**Administrative Record
for Revisions to
Prevention of Significant Deterioration (PSD)
&
Minor New Source Review
Air Permits**

PotlatchDeltic Land & Lumber LLC
St. Maries Complex
St. Maries, Idaho
Coeur d'Alene Reservation

Final Revisions to Permits
October 10, 2019

SUBJECT: Monitoring the Temperature of the Air Inside Lumber Dry Kiln LK-6 at PotlatchDeltic's St. Maries Complex

The illustration was extracted from both the Fact Sheet to the PSD permit and the Permit Analysis to the minor NSR permit.

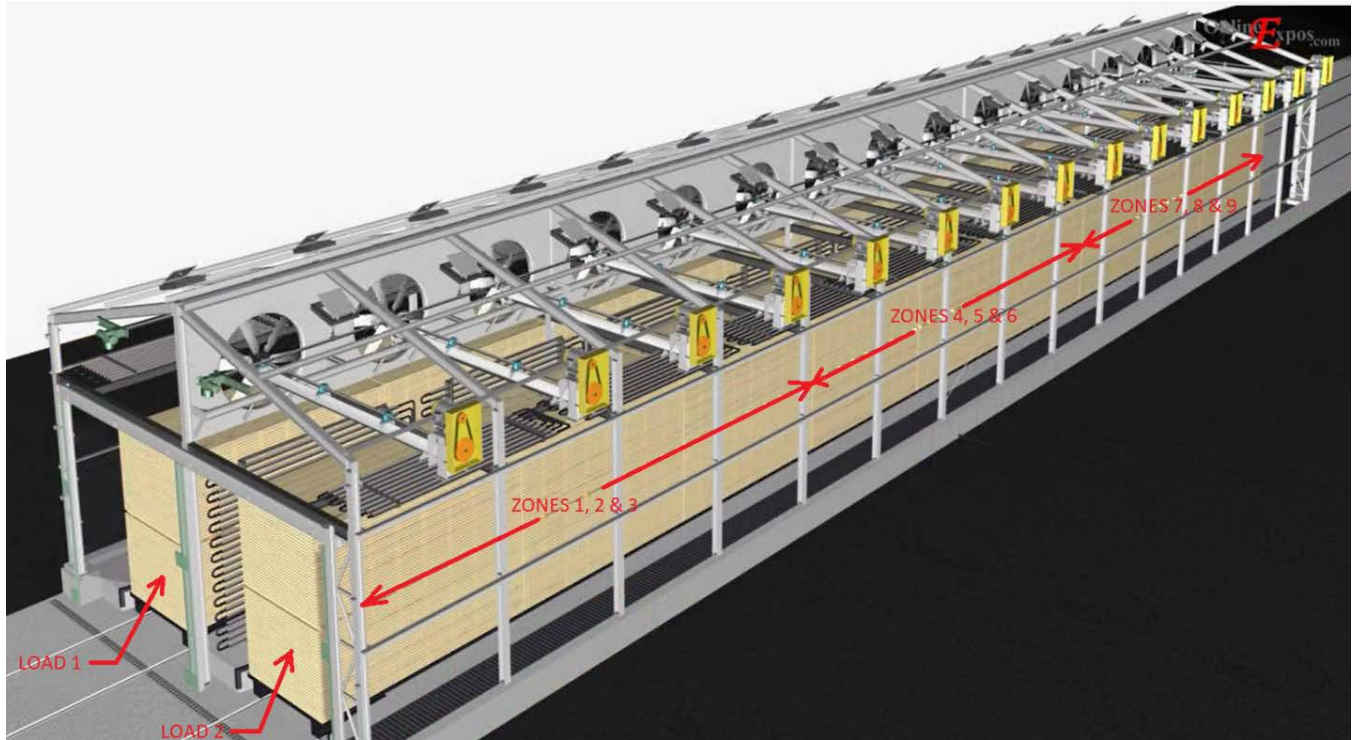
Section 1 of the current permits erroneously refers to the kiln as being designed with ten heating zones arranged along the length of the kiln as follows:

This proposed revision lists the kiln as have 20 zones instead of the original wording of 10 zones in the final permit. We would prefer to keep the 10 zone wording in the final permit. We don't believe that specifying 20 zones is as representative of our operation of the kiln, since the proposed additional 10 zones are just lower sections of the kiln. They do not have their own vents, so airflow is more aligned with the 10 zone wording of the original permit. These changes are presented below.

Finally, let us know if Dan's revised description of the zone structure and placement of temperature sensors is accurate. Also, whether you think there is value in having the diagram in section 1 or whether it doesn't add value or creates confusion (I expect that our terminology doesn't match up with yours).

We agree that we need to stay with the original language of 10 zones – they are just arranged different than we thought – Dan thought that there were 10 zones running down the length of the kiln and we now know that there are 5 zones running the length of each load. And we’ve always understood that there are 20 pairs of dry bulb thermometers – 10 in each load – again just arranged differently than we originally thought.

to several days depending upon several factors. ~~As illustrated in the following drawing, the~~ The kiln is designed with 20 10 heating zones arranged along the length and width of the kiln from the entrance to the exit wherein the drying process can be separately controlled.
